UNITED STATES
DEPARTMENT OF THE INTERIOR
BUREAU OF LAND MANAGEMENT
APPLICATION FOR PERMIT TO DRILL OR REENTER

1a. Type of work: <input checked="" type="checkbox"/> DRILL <input type="checkbox"/> REENTER 1b. Type of Well: <input checked="" type="checkbox"/> Oil Well <input type="checkbox"/> Gas Well <input type="checkbox"/> Other 1c. Type of Completion: <input type="checkbox"/> Hydraulic Fracturing <input checked="" type="checkbox"/> Single Zone <input type="checkbox"/> Multiple Zone		5. Lease Serial No. NMNM102917 6. If Indian, Allottee or Tribe Name 7. If Unit or CA Agreement, Name and No. 8. Lease Name and Well No. CASEY JONES 21 FED COM 731H 9. API Well No. 30-015-54133

Approval Date: 08/23/2023

COA

Proposed Wellbore

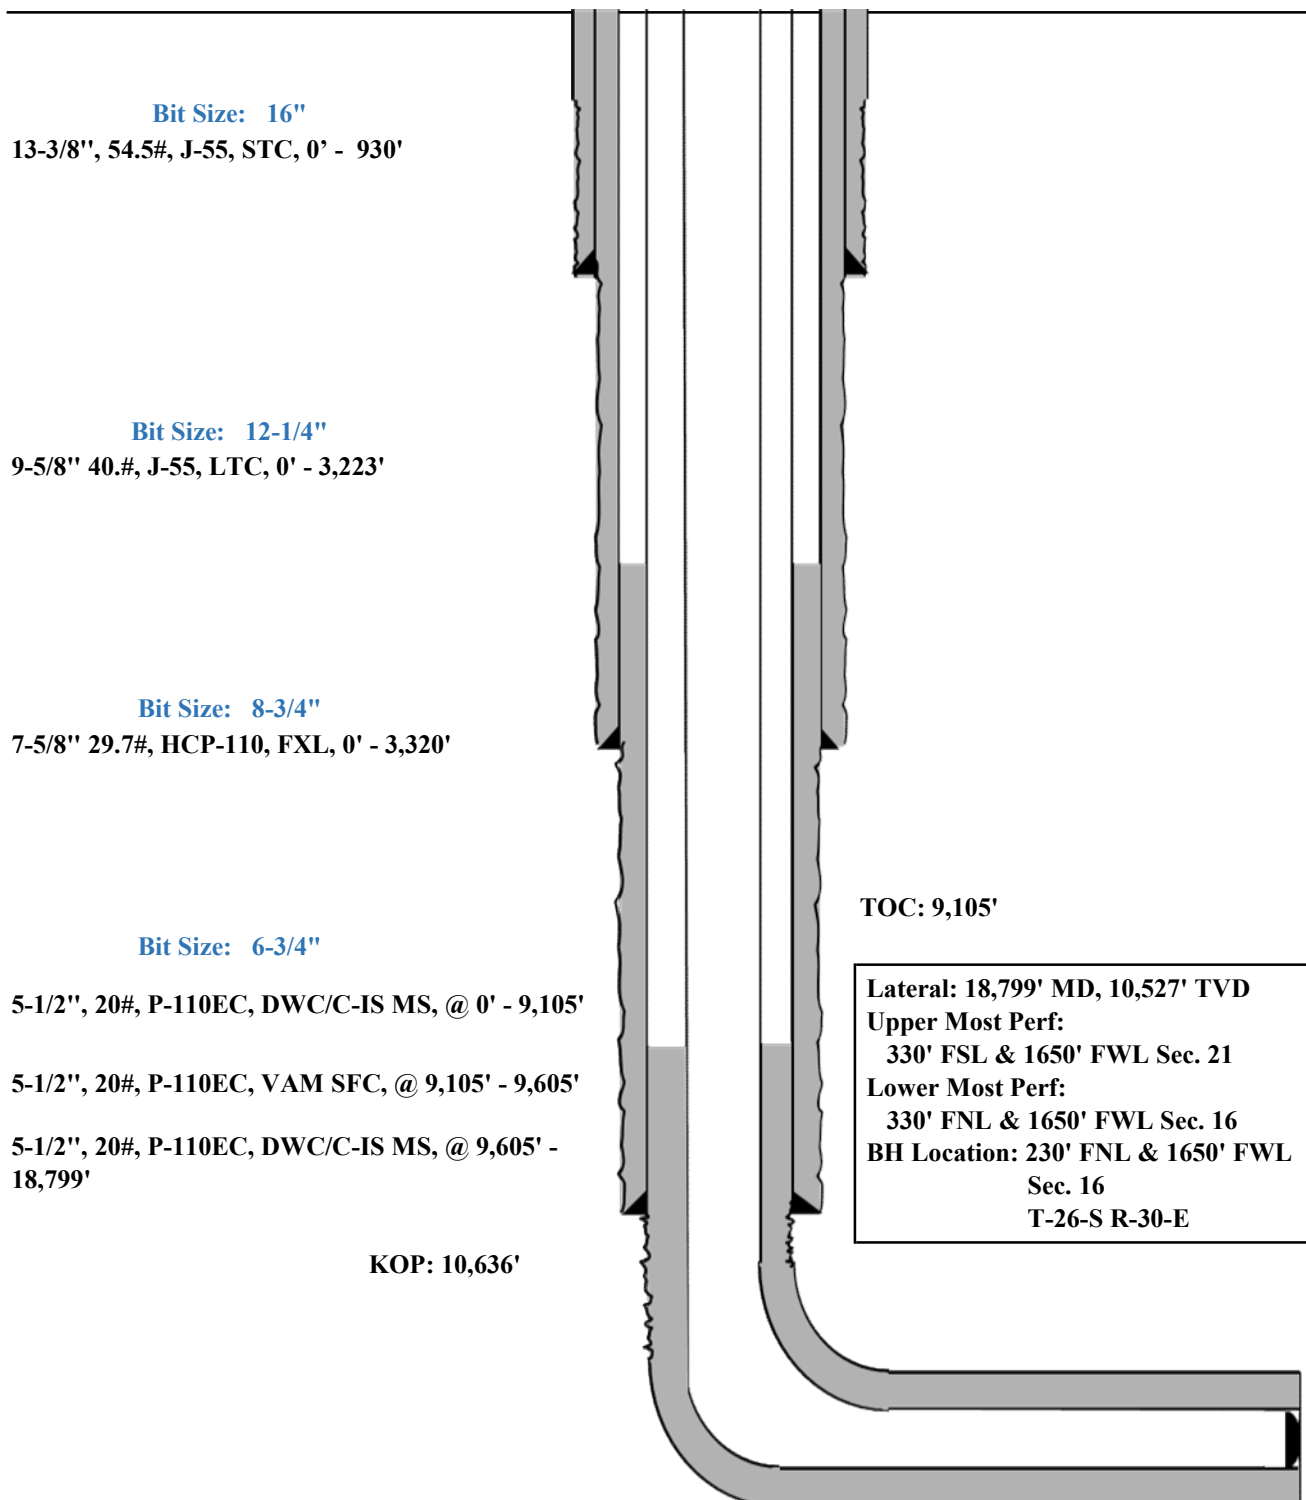
Operator has proposed to pump down 9-5/8" X 7-5/8" annulus after primary cementing stage. Operator must run Echo-meter to verify Cement Slurry/Fluid top in the annulus Or operator shall run a CBL from TD of the 7-5/8" casing to surface after the second stage BH to verify TOC.

3. The minimum required fill of cement behind the **5-1/2** inch production casing is:
 - Cement should tie-back at least **200 feet** into previous casing string due to operator not meeting casing clearance requirement per 43 CFR 3170. Operator shall provide method of verification.
